SERVICE PROCEDURE

G-07511 SEPTEMBER 2007

SUBJECT: SAFETY RECALL (U.S., EXPORT)

SR-7[™] SPRING BRAKE MODULATING VALVE on certain 5900*i*, 7000 and 8600 Models built 11/1/2005

Figure 1 - BENDIX® SR-7™ SPRING BRAKE MODULATING VALVE PORT DESIGNATIONS AND KIT CONTENTS

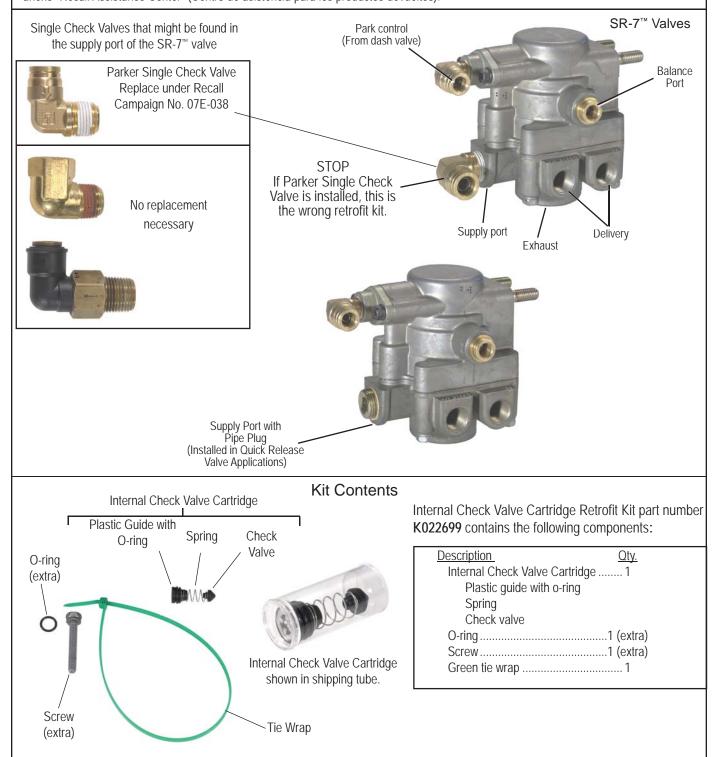
- Locate the SR-7[™] spring brake modulating valve on the vehicle. Typically it is located near the rear axle mounted on the frame rail or cross member.
- Identify the supply (SUP 1) port. Note: this port will contain either an external single check valve or a pipe plug. Refer to Figure 1.
- 3. If an external single check valve is present, disconnect the air line to the check valve. Refer to Figures 2 and 3.

- 5. If the removed SR-7™ valve contains an external single check valve in the supply port, identify the type of single check valve. If the SR-7™ valve contains a Parker single check valve, do not reuse it in the replacement valve. Refer to Figure 1 for single check valve identification. The Parker single check valve is covered by Recall Campaign No. 07E-038. Contact the Bendix Recall Center for a replacement.
